ZIONSVILLE PLAN COMMISSION MEETING RESULTS
Monday July 18, 2016

Petition Number: 2016-05-PP

Request: Petition for Primary Plat approval in order to subdivide 77.015 acres into twelve (12) lot subdivision, in the (R2), Rural Low Density Single and Two Family Residential Zoning District, and the (R-SF-2), Urban Single Family Zoning District

To: Wayne DeLong, Director of Planning and Economic Development
 From: Mark DeBruler, P.E., Town Engineer *md*
 Date: May 18, 2016

Exhibit 3

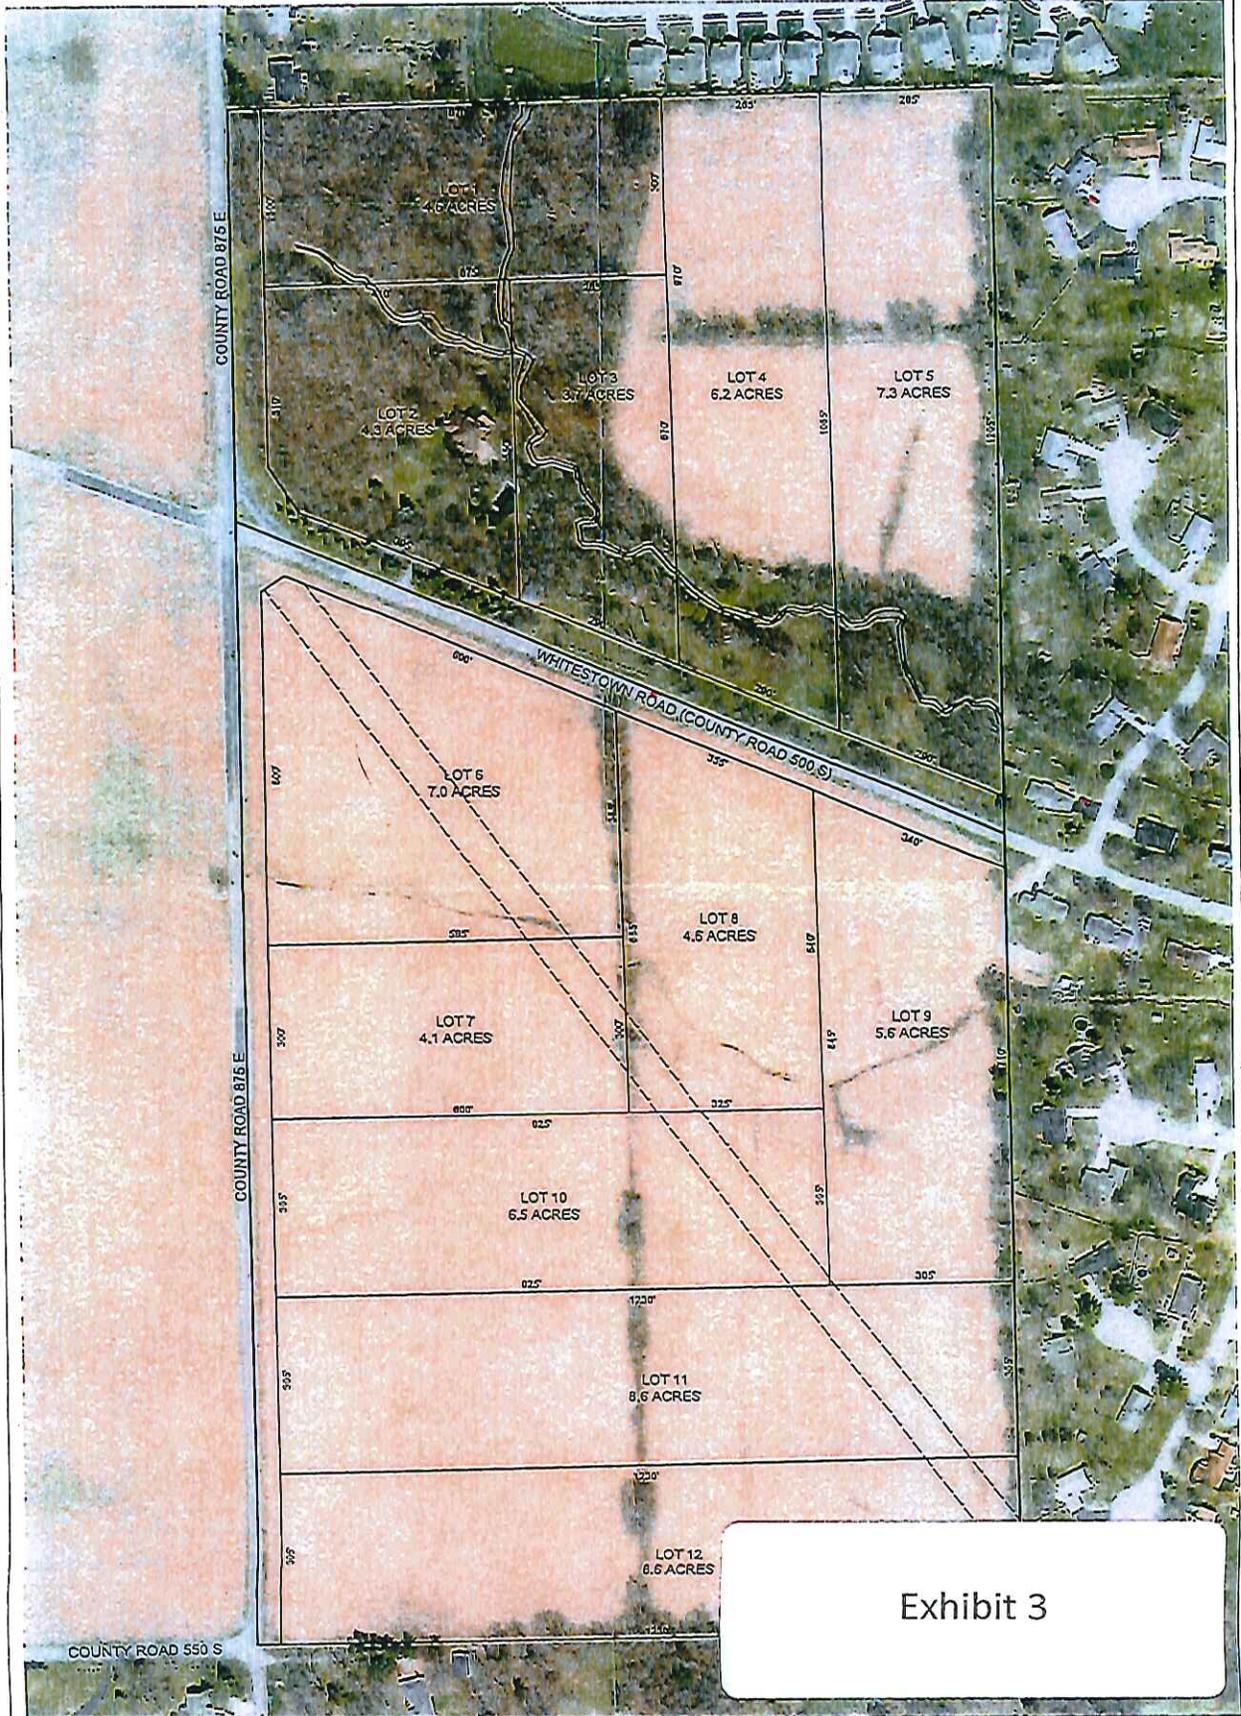
- I. PRIMARY MINOR PLAT
 - A. Sections 1 and 2, as described in the covenants, need to be identified on the plat.
 - B. Provide an address plan.
 - C. Provide Minimum Flood Protection Grade (FPG) for each lot since we do not anticipate submission of construction plans for this development.

- A. Sections 1 and 2, as described in the covenants, need to be identified on the development plan.
- B. The Section 2 covenant indicates the replaced tile is to be perforated pipe. The development plan does not address whether the pipe is to be perforated or unperforated. Please clarify the type of pipe in the development plan and revise the covenants if required for consistency.

- C. Provide a plan and profile sheet of the proposed 18" replacement field tile. Indicate if the pipe is perforated or unperforated.
- D. Provide details, including the weir elevation, of the apparatus on Lot 9 that discharges overland flow to Sycamore Bend.

- E. Detail the proposed off-site storm water improvements in Sycamore Bend. Provide documentation that these improvements are acceptable to the Boone County Surveyor's Office.

- F. Provide a sidewalk plan or make arrangements acceptable to the Planning Department for their future installation.
